Planning Commission

Revised Meeting Agenda

May 11, 2026 | 6:30 PM

SUBJECT: Building Elevation Modifications, Braelinn Village Shopping Center, Crosstown Drive

L1

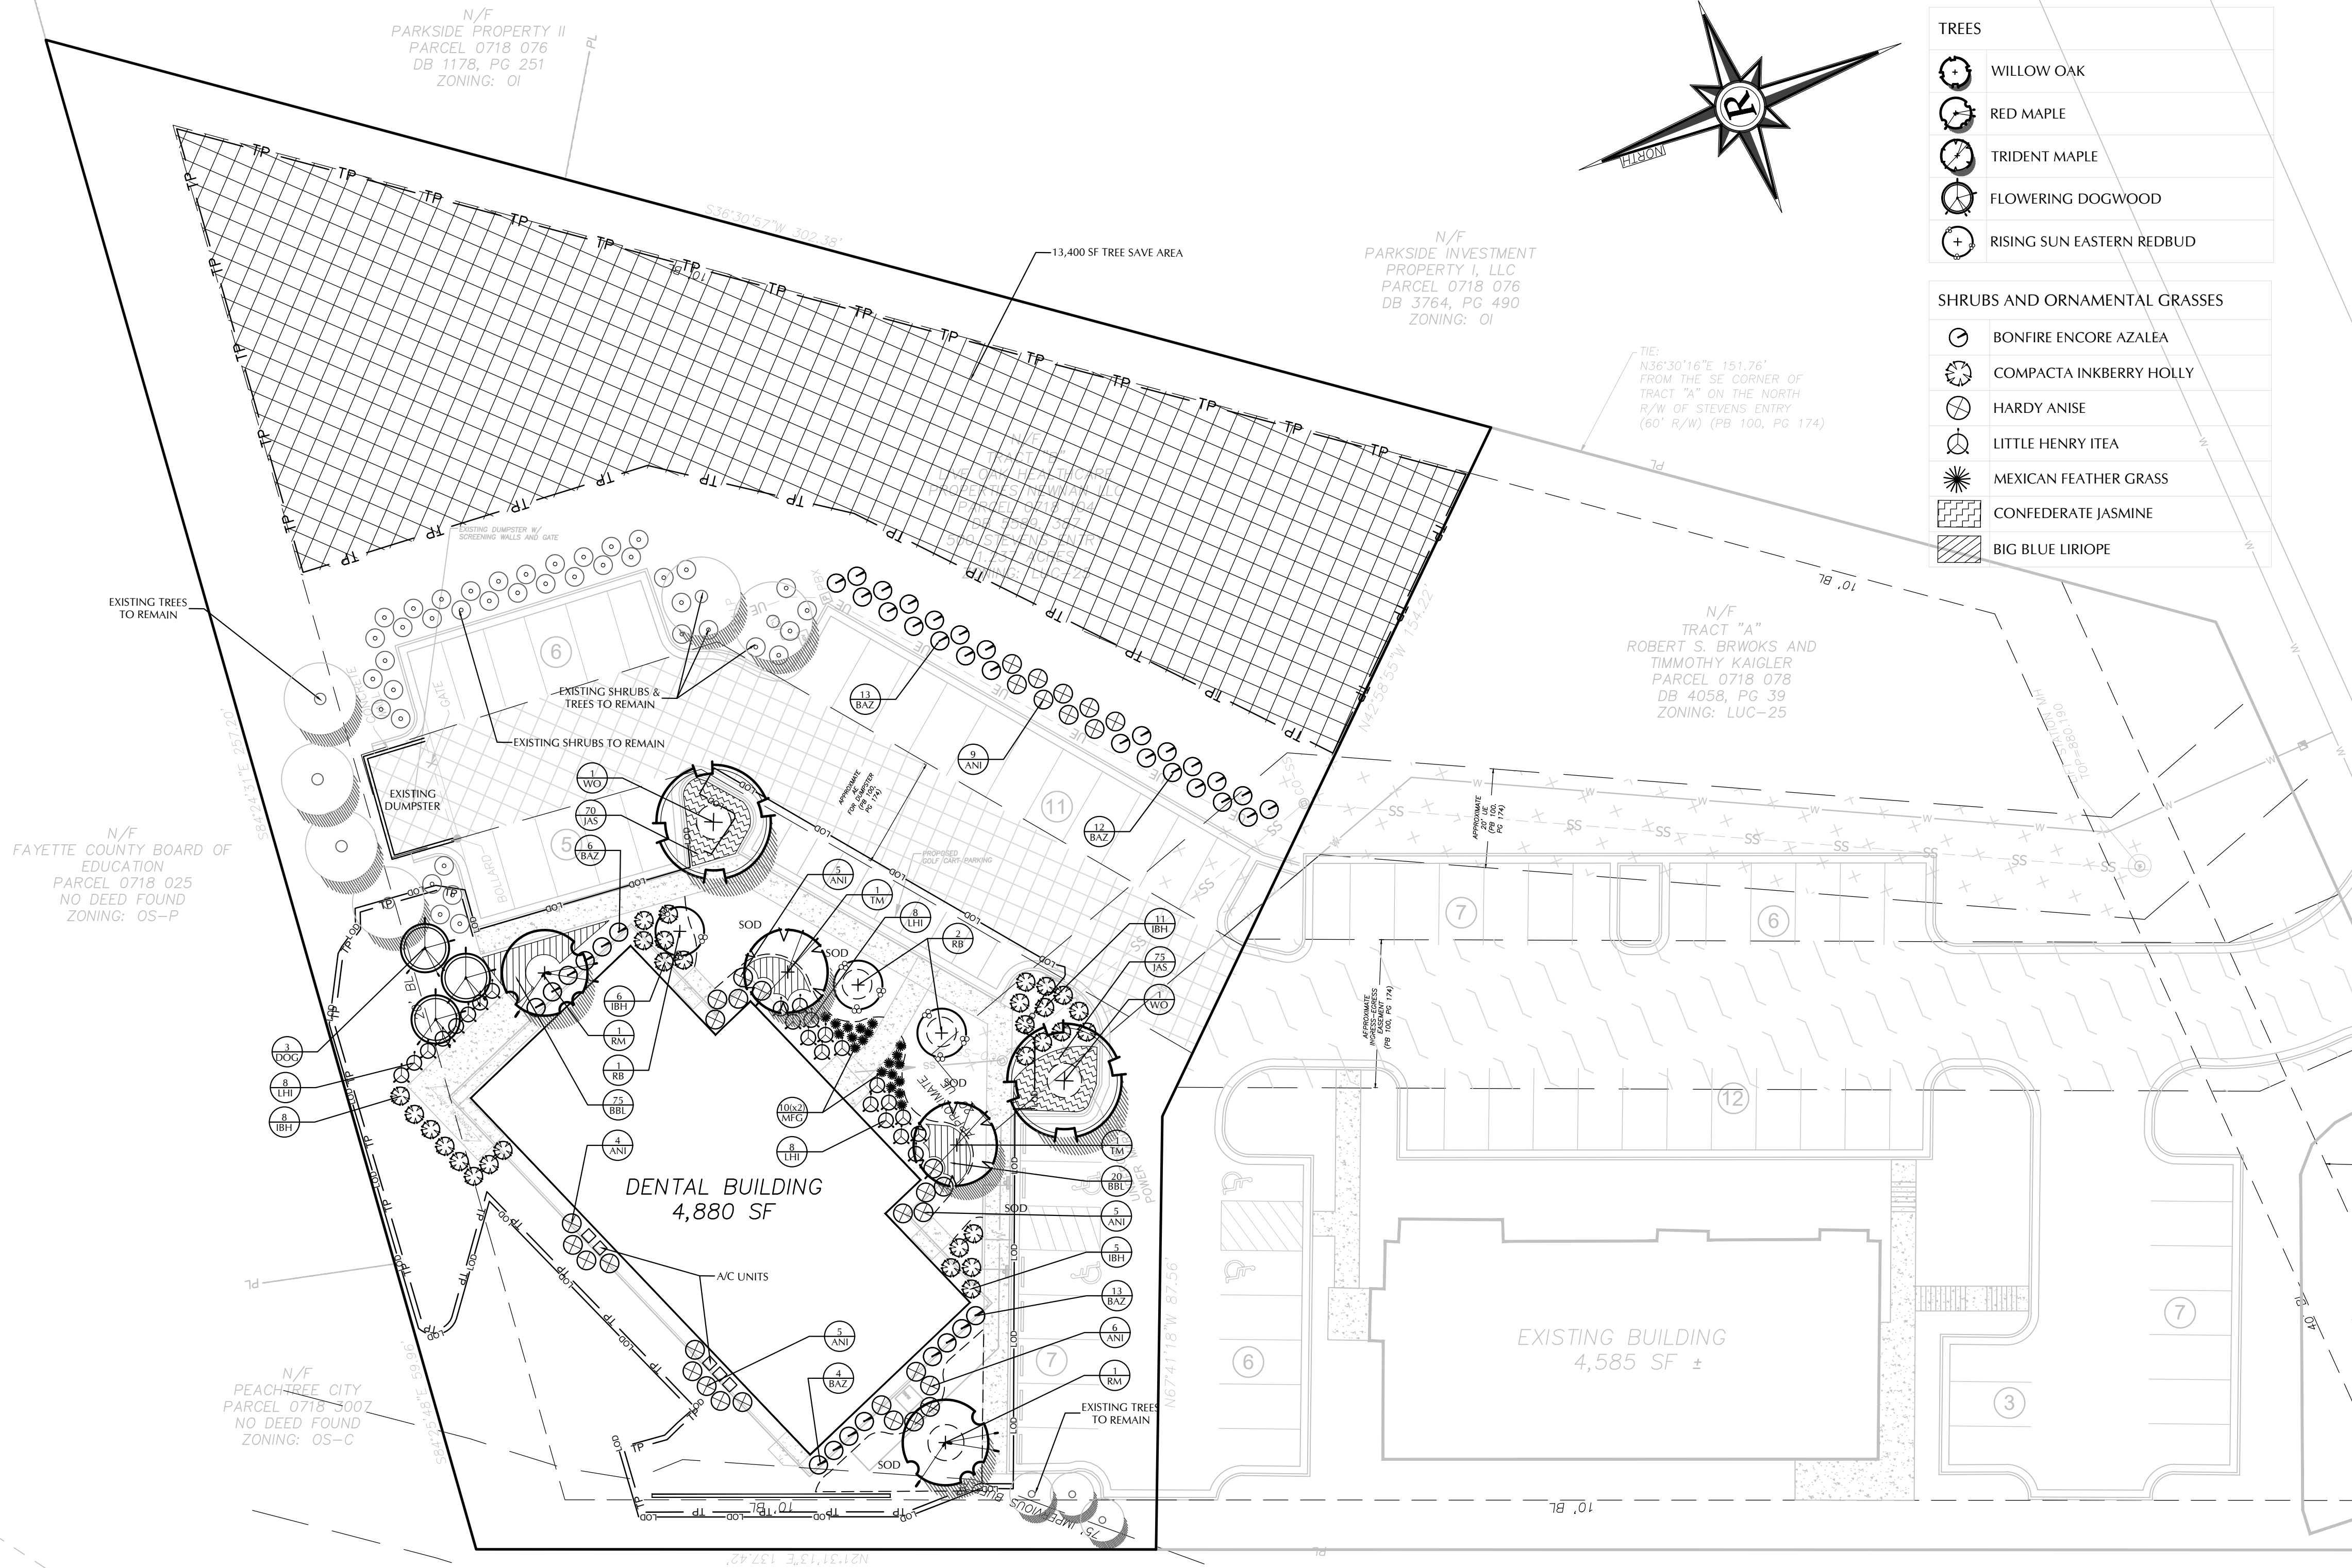
Staff believes that the proposed landscape plan for 500 Stevens Entry meets the city's landscape ordinance requirements. Should the Planning Commission decide to approve the plan, staff has no recommended conditions.

The parking area on this property is existing. The amount of new impervious surface area for the construction of the building is 5,015 SF, which includes structures, drives, parking areas, and sidewalks minus the existing impervious area. The landscape ordinance requires a minimum of 15 caliper inches of canopy trees and 10 caliper inches of understory trees for 5,015 SF of impervious area.

The proposal is for 18 canopy inches (6 trees) and 12 understory inches (6 trees). The amount of inches provided exceeds the requirement. Therefore, no alternative compliance method is required. In addition, there is a large tree save area on the east side of the property (13,400 SF) plus nine existing trees and several existing shrubs to remain.

As part of the ordinance requirements, planting areas shall be located in front and on the sides of all retail, commercial and industrial buildings, wherever practical. The proposal includes a planting area along the front and both sides of the building. Additional shrubs are provided to screen the A/C units behind the building.

In addition, the perimeter of all parking lots shall be landscaped with evergreen shrubs. The shrubs shall be no less than 24 inches in height at the time of planting. The applicant is proposing azaleas and Hardy Anise along the east side of the parking area.

trees, evergreen shrubs, and/or groundcover in mulched beds. The proposal includes Willow Oaks, Inkberry Holly, and groundcover in the parking islands.

Of the total number of plant species proposed, 58% are native to the eastern United States and/or the southeastern United States.
